AGENDA - LPP

REPORT TO GEORGES RIVER COUNCIL LPP MEETING OF THURSDAY, 04 AUGUST 2022

LPP Report No	LPP034-22	Development Application No	DA2021/0180
Site Address & Ward Locality	20A Algernon Street, Oatley Peakhurst Ward		
Proposed Development	Construction of a dwelling house, swimming pool and driveway		
Owners	Raga Diab		
Applicant	Amin Nasser		
Planner/Architect	BMA Urban/ Katris Architects		
Date Of Lodgement	6/05/2021		
Submissions	14 submissions		
Cost of Works	\$985, 925.12		
Local Planning Panel Criteria	More than 5 submissions were received and the applicant is requesting a variation to the Foreshore Building Line.		
List of all relevant s.4.15 matters (formerly s79C(1)(a))	State Environmental Planning Policy (Biodiversity and Conservation) 2021, State Environmental Planning Policy (Resilience and Hazards) 2021, State Environmental Planning Policy (BASIX) 2004, State Environmental Planning Policy (Transport and Infrastructure) 2021, Kogarah Local Environmental Plan 2012, Kogarah Development Control Plan 2013, Georges River Local Environmental Plan 2021.

LPP Report No	LPP035-22	Development Application No	DA2021/0047
Site Address & Ward Locality	977 Forest Road, Lugarno Pe

Figure 9: Site Plan showing the extent of the encroachment beyond the 30m FBL

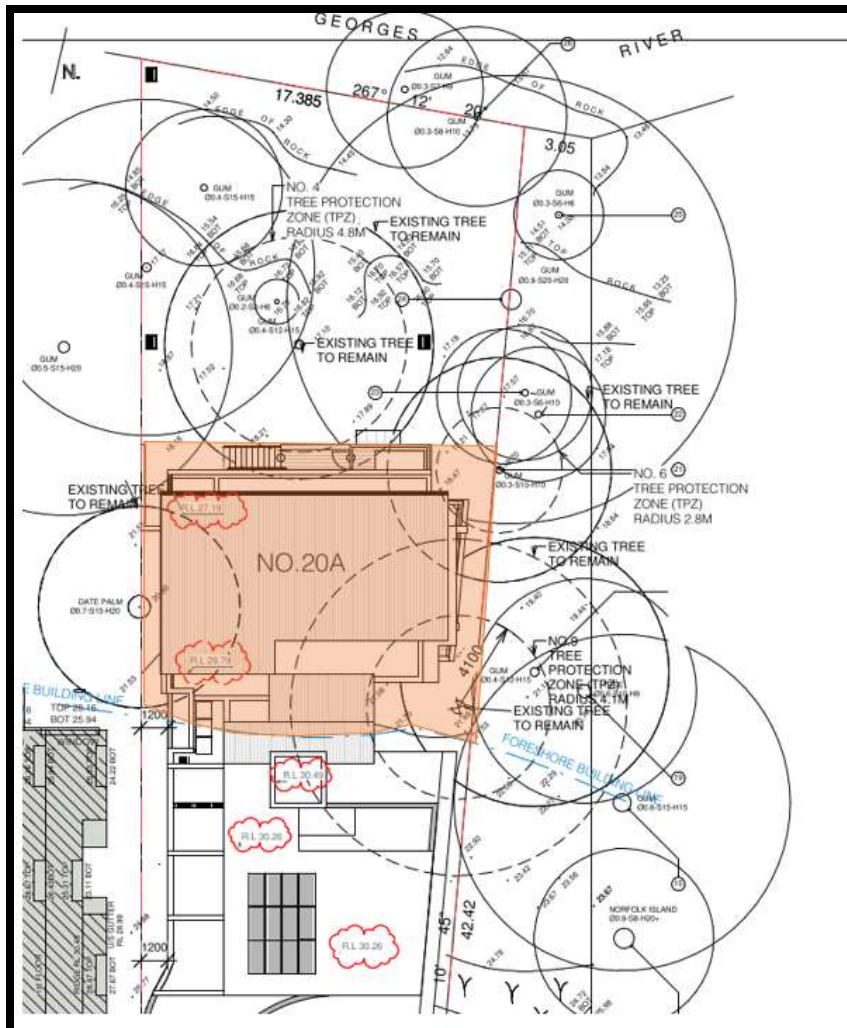
59. The proposed development encroaches the FBL by 16m at all levels of the proposal. This breach amounts to a 46% variation of the control. The extent of the breach is shown in the figure below.

71. The significant breach of the foreshore building line and its visual prominence when viewed from the waterway and adjoining sites is therefore contrary to the objectives of the control.
72. The foreshore building line standard is the primary planning control applicable to the site to which development must respond and to which the design of the dwelling should consider. In addressing this matter in their variation request, the applicant states (Council Officer's underline):

73. This statement is not accepted. It is considered, rather, that as demonstrated in Figure 12 above, while there are examples of existing dwellings forward of the FBL, none exhibit the extent of encroachment of the FBL when compared to the proposed dwelling (excluding waterfront structures such as boatsheds), either in terms of height or extent, and the site has no particular feature that would mitigate the usual impacts of the breach on the foreshore.

Figure 9: Elevation showing height non-compliance (Source: SEE by Planning Ingenuity)

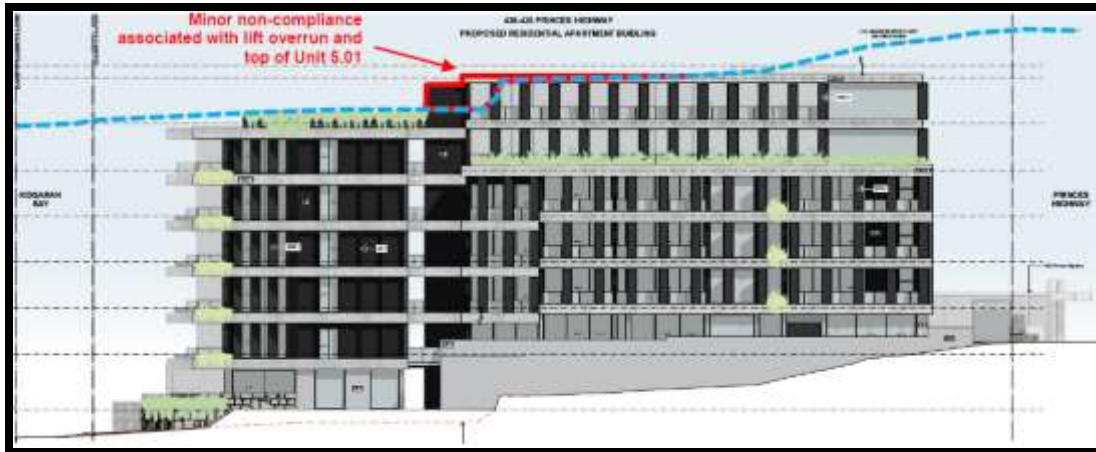
75. Any variation to a statutory control can only be considered under Clause 4.6 – Exceptions to Development Standards of the KLEP. An assessment of the proposed height against the survey plan levels was conducted to indicate the Applicant's calculations are generally accurate.
